RCA-64-22-006-1: Remove Clip Tower from Upper C-Pillar Trim Panels

Document Type	Customer Satisfaction Campaign Bulletin
Date	December 15, 2022
Affected Region(s)	USA
Affected Model(s)	R1T
Model Year(s)	2022
Approximate Build Dates  Refer to the FSA Dashboard to determine if this document applies to a specific vehicle.	August 2021 - November 2022
Vehicle System	64 - Interior
Minimum Service Location	Mobile

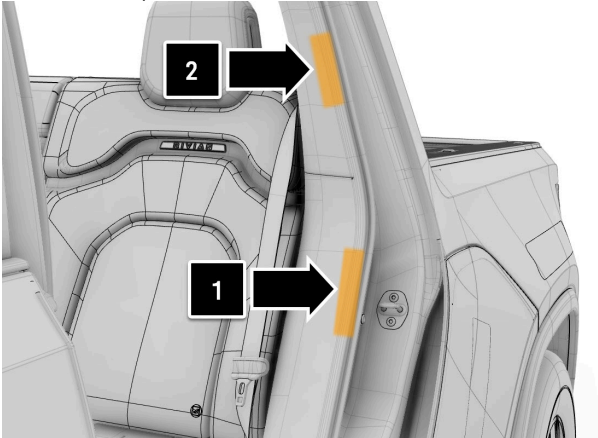
2. Use the inflatable wedges in the highlighted areas to gain access to the forward clips on the LH upper C-Pillar trim panel.

**Tip:** Pull back the secondary door seal as necessary to insert the inflatable wedges.

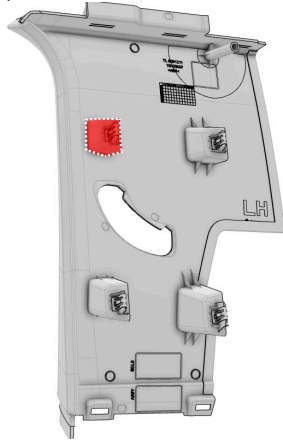
3. Using adjustable pliers: Remove:

Tip: If necessary: Use a utility knife to score the base of the clip tower.

Note: Shown with components removed for clarity.
